PERMIT

SEWAGE DISPOSAL SYSTEM
HOWARD COUNTY HEALTH DEPARTMENT
BUREAU OF ENVIRONMENTAL HEALTH
410-313-2640

SUBDIVISION Peacefields @ Cattail Creek LOT NUMBER 10 ADDRESS 15525 Cattail Oaks

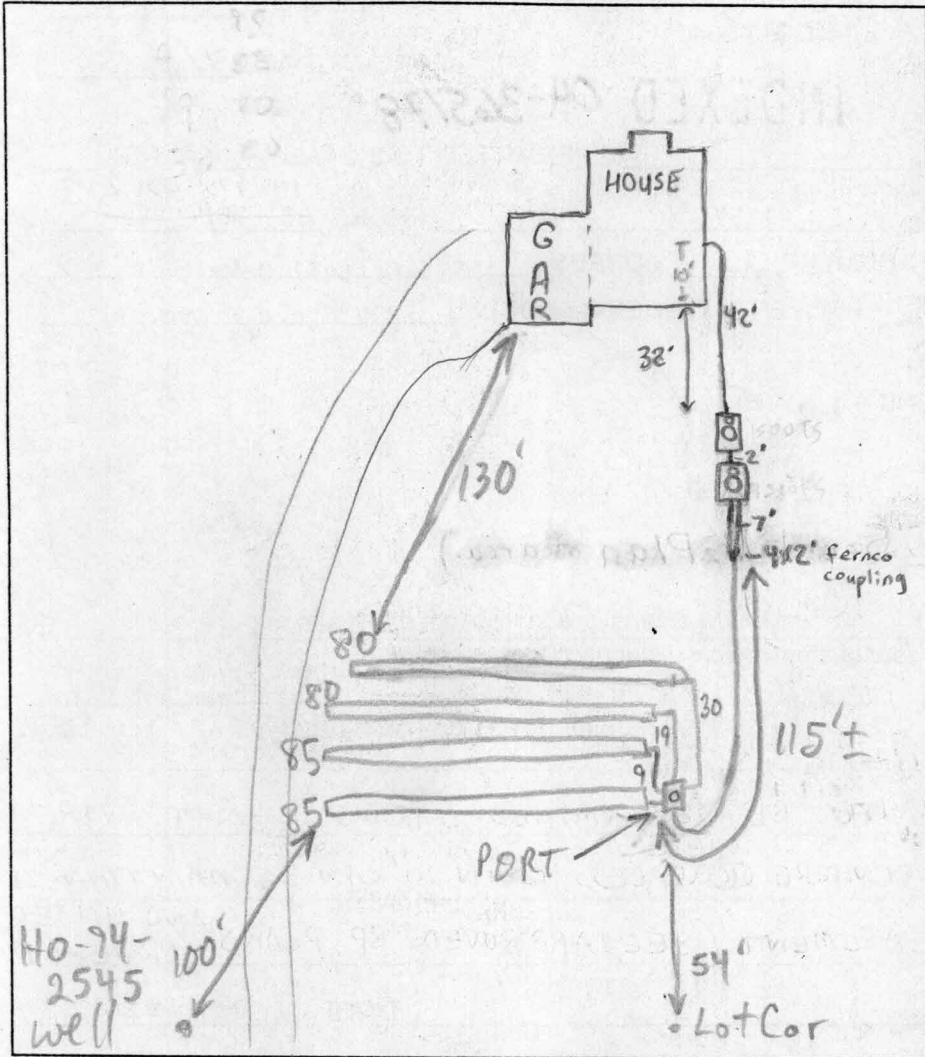
PRE-CONSTRUCTION INSPECTION: 5/30/01 Upper trenches to be installed slightly off contour and not as crescent shaped in order to conserve lower area. - 7' edge to edge (BB)

INSPECTION COMMENTS: 6/29/01 - OK TO CONTINUE WORK - (SRK)

7/3/01 OK TO COVER TRENCHES, HOLD FOR PUMP/ALARM INSP (MR)

7/20/01 Pump and alarm working. (BB)
